## Accessibility Review Report – DA Review

**Project Title:** IC3 West Data Centre  
17-23 Talavera Road, Macquarie Park

**Report Version:** 21302\_ADR\_DA\_v1.2

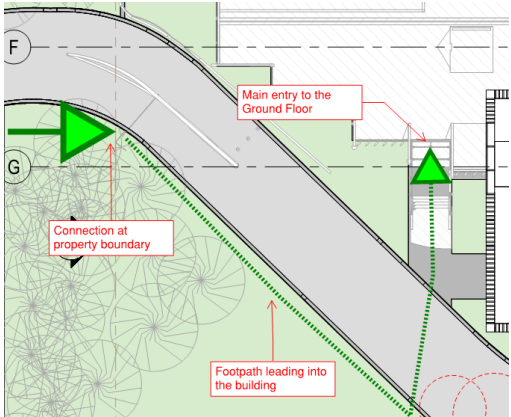
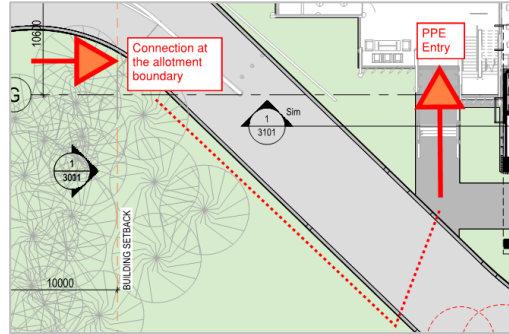
DtS Provision	Comment(s)/Recommendation(s)	Status
<p>Buildings and parts of the building must be accessible as required by Table D3.1, unless exempted by D3.4. Table D3.1 requires that access is provided –</p> <p><b><u>Class 5, 6, 7b, 8, 9a –</u></b></p> <ul style="list-style-type: none"> <li>To and within all areas normally used by the occupants.</li> </ul> <p><b><u>Class 7a –</u></b></p> <ul style="list-style-type: none"> <li>To and within any level containing accessible carparking spaces.</li> </ul>	<p>Access is generally proposed throughout the required portions of the building as prescribed by Cl. D3.1 of the BCA.</p> <p>Compliance is readily achievable with minor design development and/or specification at the Detailed Design Stage.</p> <p><b>Note:</b> An exemption under clause D3.4 of the BCA has been applied to the following areas:</p> <ul style="list-style-type: none"> <li>Data storage halls and circulation areas on Levels 2-5 of the IC3W building.</li> <li>Associated plant and equipment rooms throughout the IC3W building.</li> <li>Loading dock on the Ground Floor of the IC3W building.</li> <li>Mezzanine offices on Level 1.</li> </ul> <p>Refer to markup below:</p>  <p><b>Typical data hall configuration on Levels 2 - 5</b></p> <p><b>Mezzanine office on Level 1</b></p> <p><b><u>Key compliance notes for “accessible” parts of the building:</u></b></p> <p><b><u>Accessways and Paths of Travel</u></b></p> <ul style="list-style-type: none"> <li>A continuous accessible path of travel shall be 1000 mm wide x 2000mm</li> </ul>	DD

<p>high (except at doorways where the height can be reduced to 1980mm).</p> <ul style="list-style-type: none"> <li>• The following turning circulation spaces shall be provided along an accessway: <ul style="list-style-type: none"> <li>○ 1500mm x 1500mm to allow for a 90 degree turn</li> <li>○ 1540mm x 2070mm to allow for a 180 degree turns. The required 180 degree turning spaces are required within 2m of the end of the accessway and at 20m intervals.</li> <li>○ 1800mm x 2000mm to allow for wheelchair passing spaces. Passing spaces are required at 20m intervals where there is no direct line of site.</li> </ul> </li> <li>• Floors finishes along an accessway must be slip resistant and not contain any stepped edges &gt;3mm or rolled edges &gt;5mm.</li> <li>• Walkways must have a complying gradient with a suitable abutment.</li> <li>• Stairways and ramps along an accessway must comply with BCA clause D3.3 and AS1428.1-2009.</li> <li>• Compliant landings must be provided for all walkways, ramps and stairways as prescribed in the Standard.</li> </ul> <p><u>Doorways</u></p> <ul style="list-style-type: none"> <li>• All doorways along an accessway (serving accessible parts of the building) are required to have a clear door opening width no less than 850mm clear and be provided with door circulation spaces as prescribed by AS1428.1-2009.</li> </ul> <p><u>Accessible Car Spaces</u></p> <ul style="list-style-type: none"> <li>• Access to and travel from any level containing accessible carparking spaces to the building must comply with AS1428.1-2009. Accessible car</li> </ul>

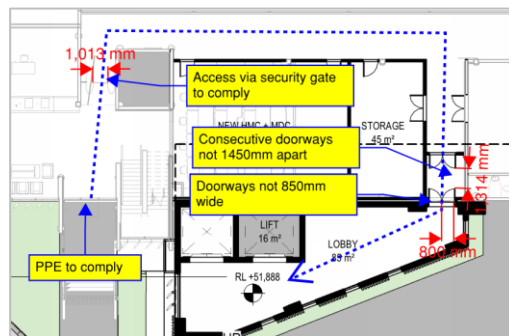
<b>DtS Provision</b>	<b>Comment(s)/Recommendation(s)</b>	<b>Status</b>
<p>An accessway must be provided to a building required to be accessible –</p> <ul style="list-style-type: none"> <li>from the main points of pedestrian entry at the allotment boundary; and</li> <li>from another accessible building connected by a pedestrian link; and</li> <li>from any required accessible carparking space on the allotment.</li> </ul> <p>In a building required to be accessible, an accessway must be provided through the principal pedestrian entrance, and –</p> <ul style="list-style-type: none"> <li>through not less than 50% of all pedestrian entrances including the principal pedestrian entrance; and</li> <li>in a building with a floor area more than 500m<sup>2</sup>, a pedestrian entrance which is not accessible must not be located more than 50m from an accessible pedestrian entrance.</li> </ul> <p>except for pedestrian entrances serving only areas exempted by D3.4.</p>	<p>The following pathway is proposed –</p> <ul style="list-style-type: none"> <li><b>1x</b> main point of pedestrian entrance to the building from Talavera Road indicated by a green arrow below. Dotted green line indicates the path of travel to the Principal Pedestrian Entry (PPE) from the boundary.</li> </ul>  <p><u>Compliance Departure(s) –</u></p> <p>A compliant accessway is not provided from the main point of pedestrian entrance at the allotment boundary and via the PPE indicated by the red arrows below –</p>	DD

The accessway via the PPE to the new passenger lifts is required to comply with BCA and AS1428.1-2009 due to the “affected part” provisions in the Premises Standard. An audit will need to be completed to verify compliance and address the following key issues:

- Access via the PPE (i.e. doorway design/details, door hardware, visual indicators etc.).
- Access through the existing security gates (gate width and card reader locations).
- Access via the existing corridors and doorways leading to the new passenger lifts.

Refer to “affected part” in red below:

- The proposed compliance departure is proposed to be addressed via a Performance Solution. This is to be determined on a case-by-case basis and will require further development / discussion at the detailed design stage.

<p>The following will need to be detailed at the design development stage:</p> <ul style="list-style-type: none"> <li>• Ensure access via the PPE complies with AS1428.1-2009.</li> <li>• Access via the security gates is to allow for a compliant 1m path of travel and swipe card readers at the prescribed locations.</li> <li>• Doorways to achieve an 850mm clear opening width and circulation as prescribed by AS1428.1-2009.</li> <li>• Doorway design including hardware, opening force and contrast to comply with AS1428.1-2009.</li> <li>• Consecutive doorways along an accessway must achieve a 1450mm clear space between the doors.</li> <li>• Travel via the existing corridors and doorways to comply with AS1428.1-2009.</li> </ul>	
--	---	--

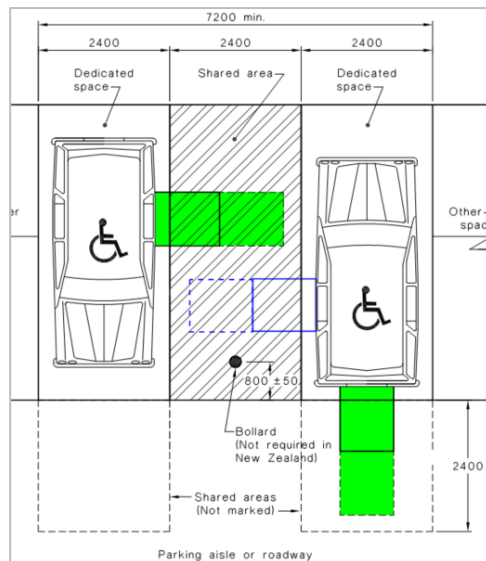
<b>DtS Provision</b>	<b>Comment(s)/Recommendation(s)</b>	<b>Status</b>
In a building required to be accessible every ramp and stairway, except for ramps and stairways in areas exempted by D3.4, must comply with –		
<ul style="list-style-type: none"> <li>• for a ramp, except a fire-isolated ramp, clause 10 of AS 1428.1; and</li> </ul>	<p>All non-fire-isolated ramps serving accessible areas are required to comply with AS1428.1-2009.</p> <p>Compliance is readily achievable with minor design development and/or specification at the Detailed Design Stage.</p>	DD
<ul style="list-style-type: none"> <li>• for a stairway, except a fire-isolated stairway, clause 11 of AS 1428.1; and</li> </ul>	<p>All non-fire-isolated stairways serving accessible areas are required to comply with AS1428.1-2009.</p> <p>Compliance is readily achievable with minor design development and/or specification at the Detailed Design Stage.</p>	DD

<ul style="list-style-type: none"> <li>• for a fire-isolated stairway, clause 11.1(f) and (g) of AS 1428.1; and</li> </ul>	<p>Stairway nosing edge strips within the fire isolated exits to be specified.</p> <p>Compliance is readily achievable with minor design development and/or specification at the Detailed Design Stage.</p>	DD

<p>Clause D2.17 of the BCA requires handrails within fire isolated exits to comply with clause 12 of AS1428.1-2009.</p> <p>To achieve a consistent handrail height throughout the stair flight and landings, the exit configuration must allow for the stairway to be offset and include the “one tread” extension of the handrail at the landings.</p> <p><i>N.B. – Cl. D2.17(a)(vi) of the BCA is generally assessed by the PCA / BCA Consultant. Where assessment of this Clause is required by this office please confirm and provide detail.</i></p>	
<p>Accessways must have—</p> <ul style="list-style-type: none"> <li>• passing spaces complying with AS 1428.1 at maximum 20 m intervals where a direct line of sight is not available</li> <li>• turning spaces complying with AS 1428.1 at 20m intervals or within 2m of the termination of an accessway.</li> </ul>	<p>Compliance is readily achievable with minor design development and/or specification at the Detailed Design Stage.</p>	DD

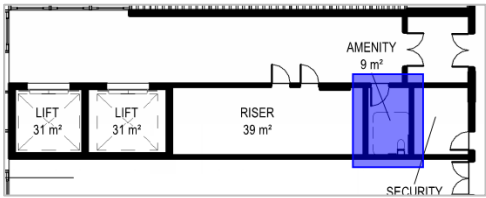
DtS Provision	Comment(s)/Recommendation(s)	Status
<p>Every passenger lift must –</p> <ul style="list-style-type: none"> <li>be one of the types identified in Table E3.6a, subject to the limitations on use specified in the Table; and</li> <li>have accessible features in accordance with Table E3.6b; and</li> <li>not rely on a constant pressure device for its operation if the lift car is fully enclosed.</li> </ul>	<p>The proposed passenger lifts shall have the following features –</p> <ul style="list-style-type: none"> <li>Handrail complying with the mandatory handrail provisions of AS1735.12,</li> <li>Lift floor dimensions not less than 1,100mm x 1,400mm where the lift vertical travel is less than 12m,</li> <li>Lift floor dimensions not less than 1,400mm x 1,600mm where the lift vertical travel is more than 12m,</li> <li>Minimum clear door opening complying with AS1735.12,</li> </ul>	DD

<ul style="list-style-type: none"> <li>• Passenger protection system complying with AS1735.12,</li> <li>• Lift landing doors at the upper landing,</li> <li>• Lift car and landing control buttons complying with AS1735.12,</li> <li>• Lighting in accordance with AS1735.12,</li> <li>• Automatic audible/visual information within the lift car and at the landings as prescribed,</li> <li>• Emergency hands-free communication, including a button that alerts a call centre of a problem and a light to signal that the call has been received.</li> </ul> <p>A design compliance certificate is be obtained from the lift designer to confirm compliance with the relevant provisions of the BCA and Australian Standards.</p> <p><u>Design Detail –</u></p> <ul style="list-style-type: none"> <li>• Ensure lift landing controls are provided no less than 500mm from an internal corner.</li> </ul>	
--	---	--
